NGUYEN PLACE SUBDIVISION

APPLICATION NUMBER 4 DATE April 6, 2017

REQUEST Subdivision

DETAIL SITE PLAN

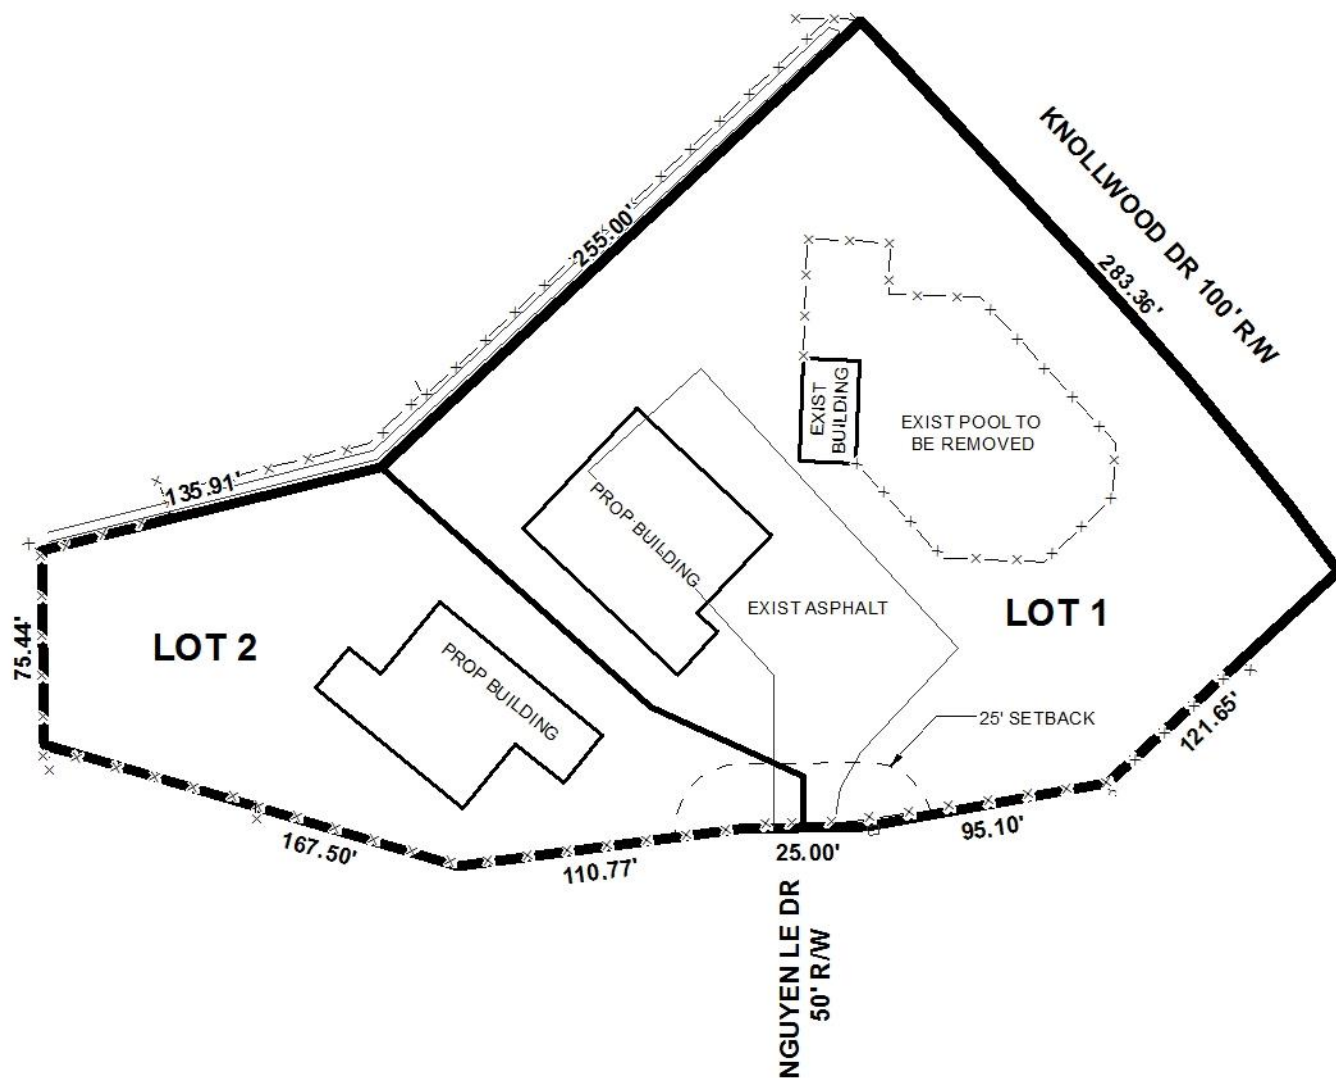
The 25-foot minimum building setback is also illustrated on the preliminary plat along Nguyen Le Drive, but not along Knollwood Drive. As such, revision of the plat to illustrate the 25' minimum building setback line along all street frontages should be required, if approved.

Finally, the site abuts Amberly Subdivision, Unit 1, to the South, and Amberly Subdivision, Unit 1-A, to the North, plats for which were recorded in Mobile County Probate Court on March 6, 1974 and June 5, 1975, respectively. Lots abutting the South property line of the subject site illustrate 7.5' drainage and utility easements; and, 15' drainage and utility easements are illustrated where lots abut the North property line of the subject site. Staff has verified that no vacations of said easements have been granted by the City Clerk's office; therefore, the plat should be revised to illustrate 15' and 7.5' drainage and utility easements along the North and South property lines, respectively, if approved. Also, if approved, a note should be placed on the Final Plat stating no structures will be constructed in any easement.

- 4) revision of the plat to illustrate the 25' minimum building setback line along all street frontages;
- 5) revision of the plat to illustrate the 15' drainage and utility easement along the North property line of each lot;

- 6) revision of the plat to illustrate the 7.5' drainage and utility easement along the South property line of each lot;
- 7) placement of a note on the Final Plat stating no structures will be constructed in any easement;
